1VC01 Owens Park, Fallowfield; Campus Redevelopment

Planning Amendments 18.03.19

Drawings & Issues Addressed

Pages 2-32
Elevations To Blocks 101-107 Showing Non-Material Amendments:

DRAWING TITLE
East and South Facing Elevations - Building 106

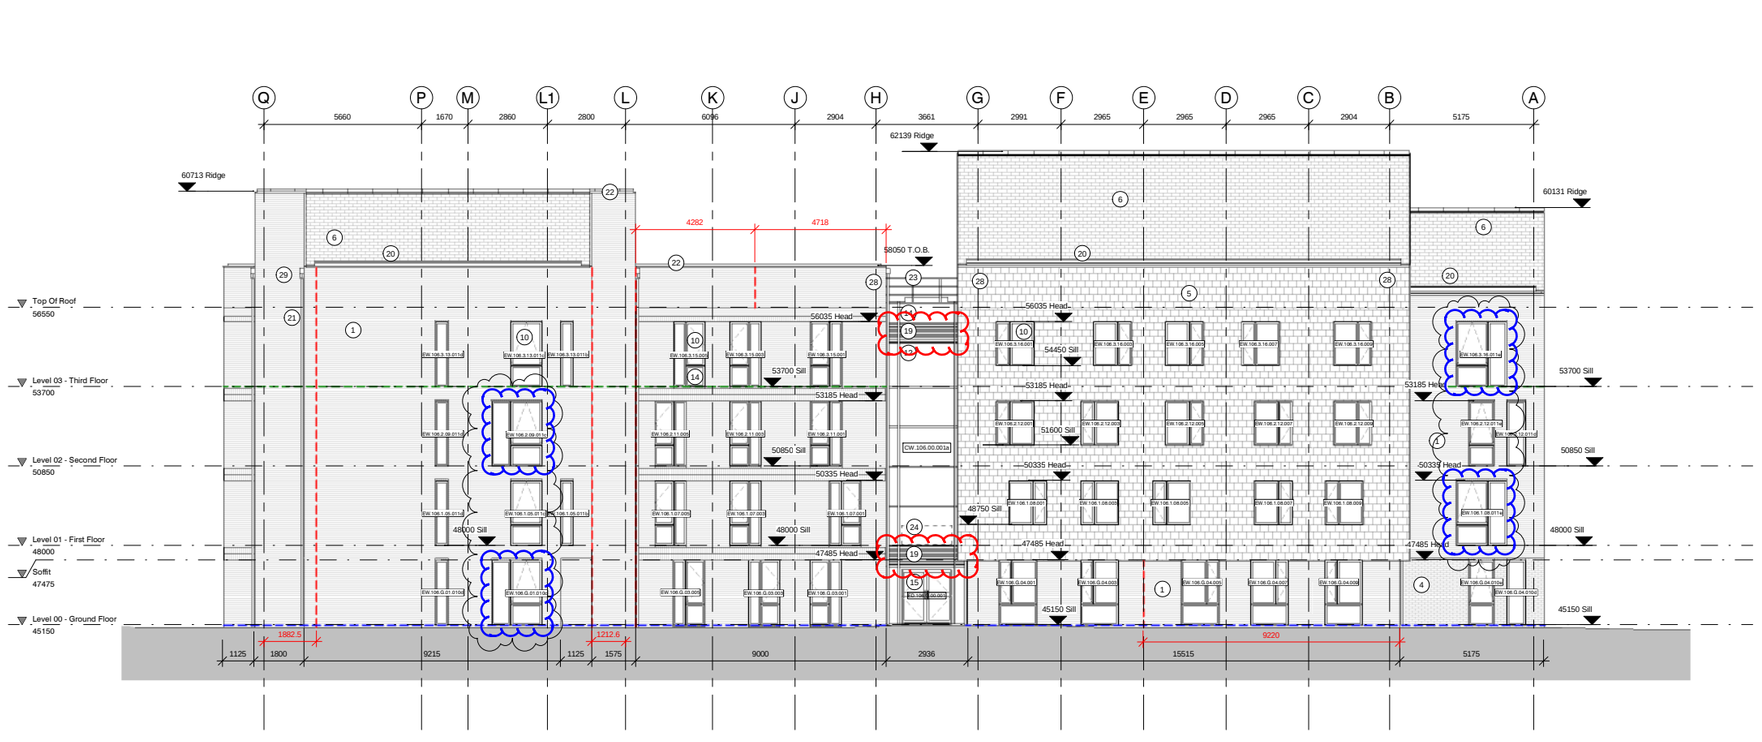
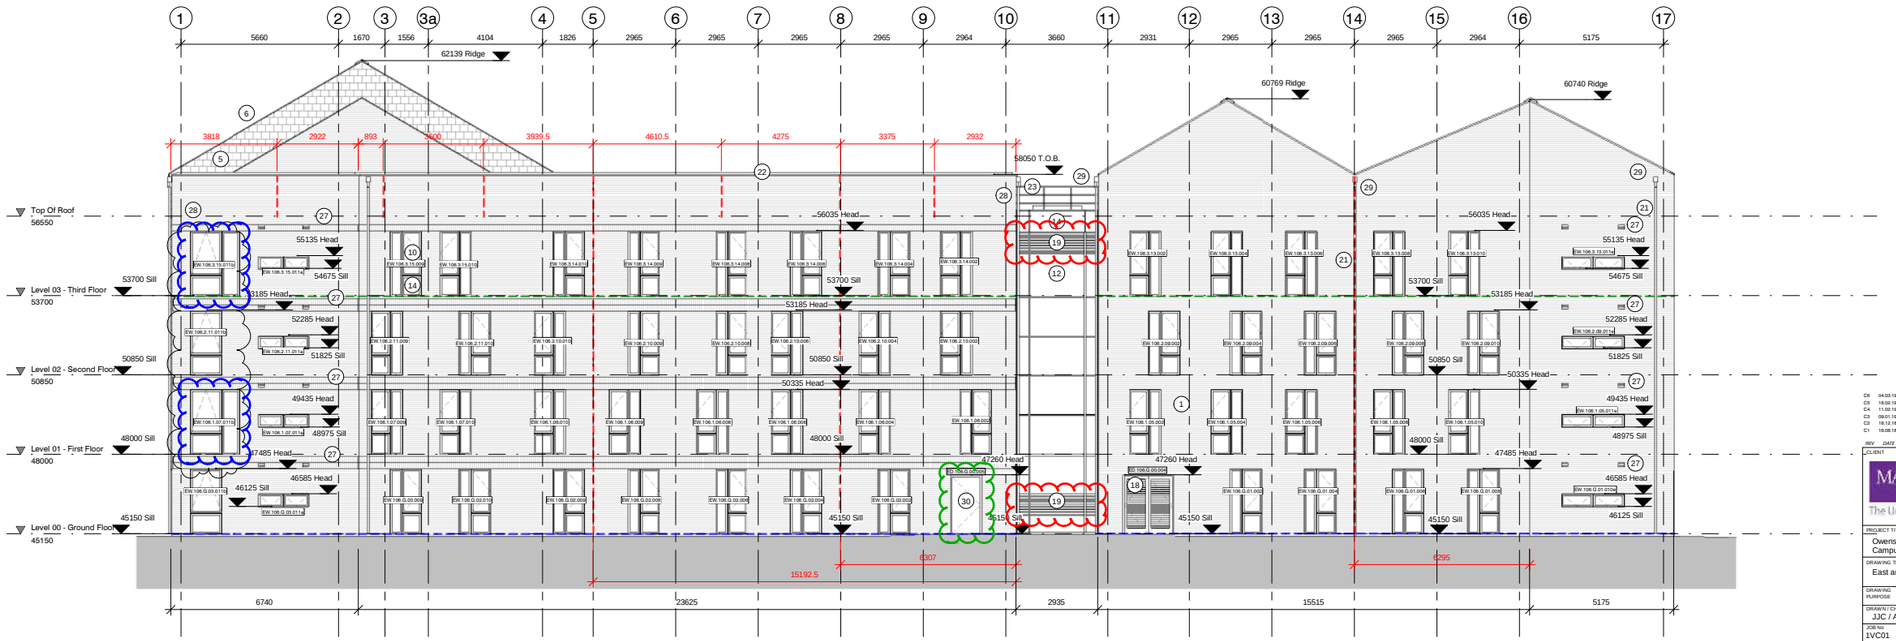
GLASS LOUVRES AMENDED TO BE PPC METAL
